SOLICITATION NO. W911WN-04-R-0003

CHARLEROI LOCKS, CONTRACT 1
CHARLEROI LOCKS AND DAM
MONONGAHELA RIVER, PENNSYLVANIA

NUMBER 5

The following changes are made to the Request for Proposal for Charleroi Locks, Contract 1, Charleroi Locks and Dam, Monongahela River, Pennsylvania:

WALL QUOIN ANCHORS

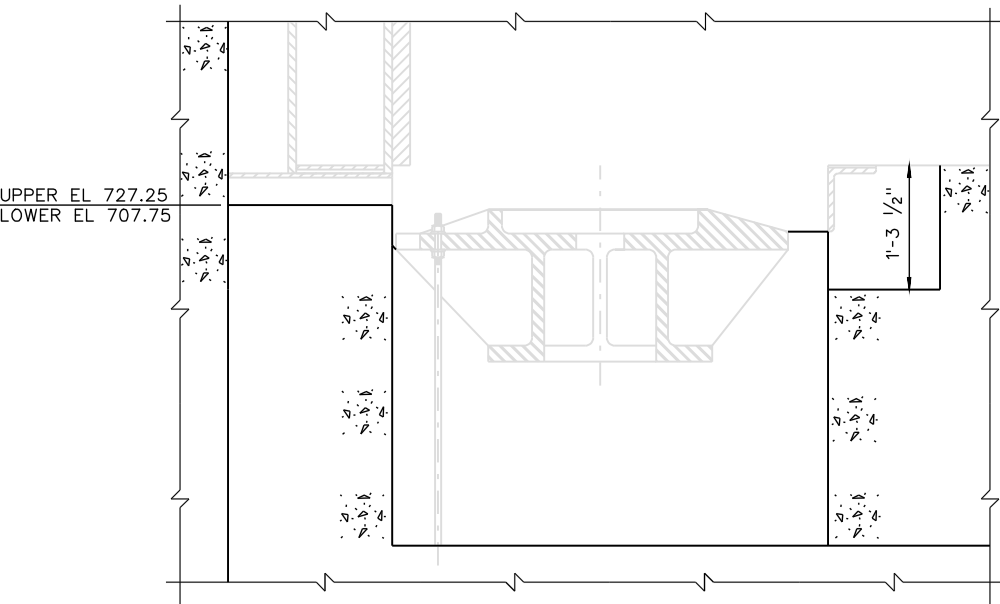
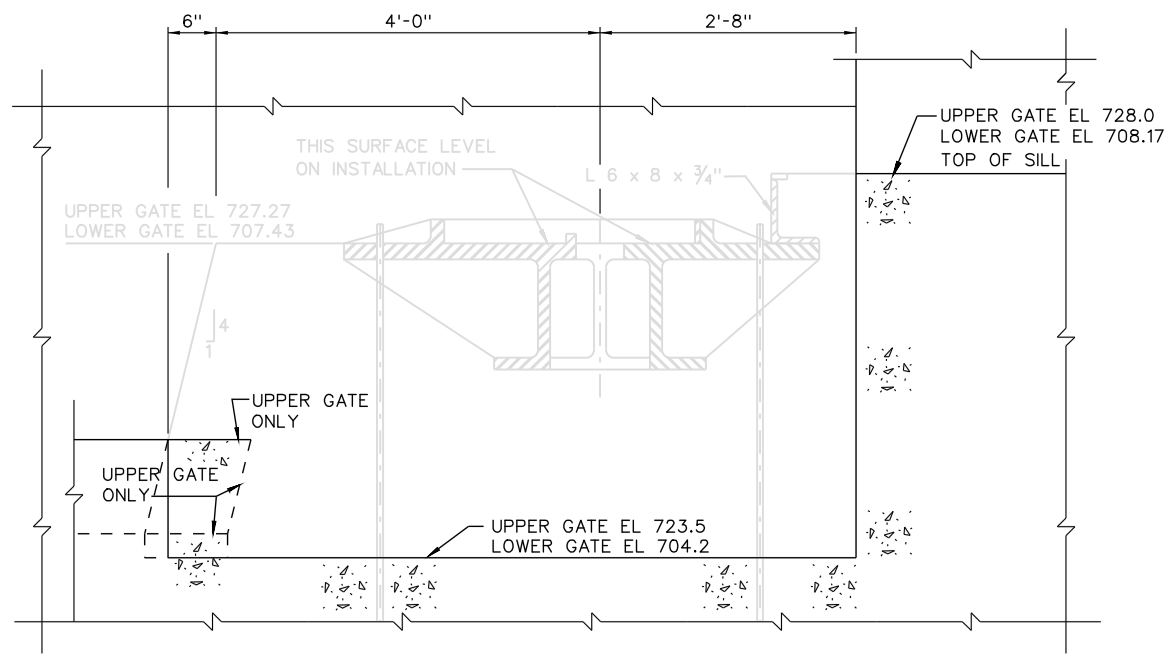
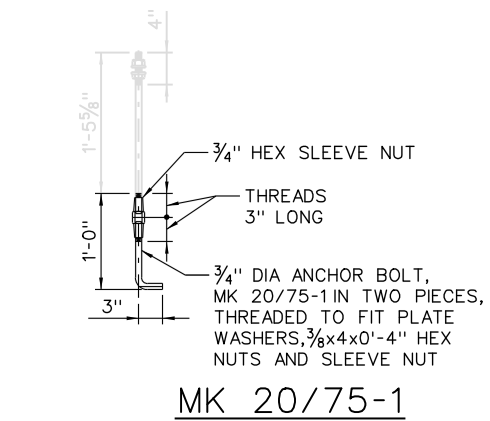
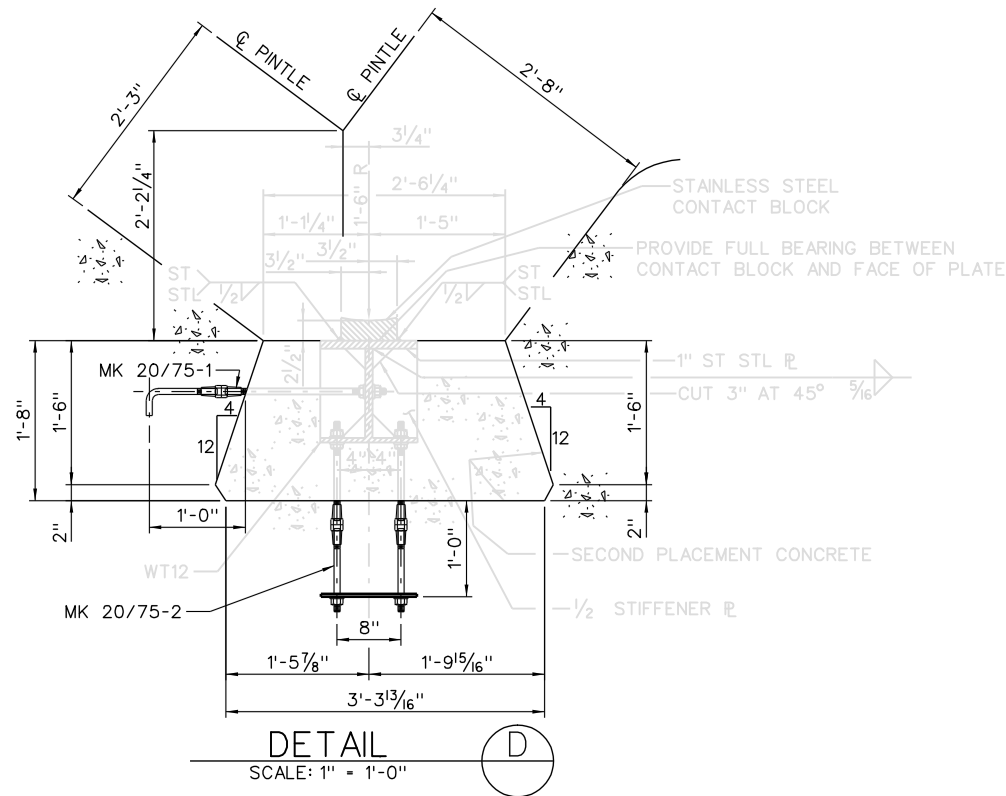
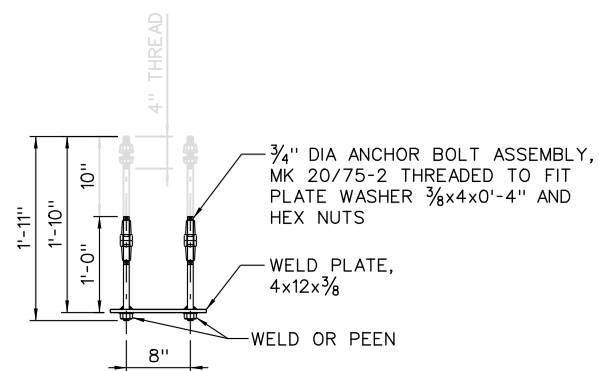
Q3 Please clarify what work or material that is shown on Drawings 20/75 and 20/82 is to be included in the contract.

A3 It is intended that only the bold features are to be provided under this contract. "half tone" or "grey-shaded" features will be provided or constructed under separate contract. on Drawing 20/75, only the wall quoin anchors are to be provided.
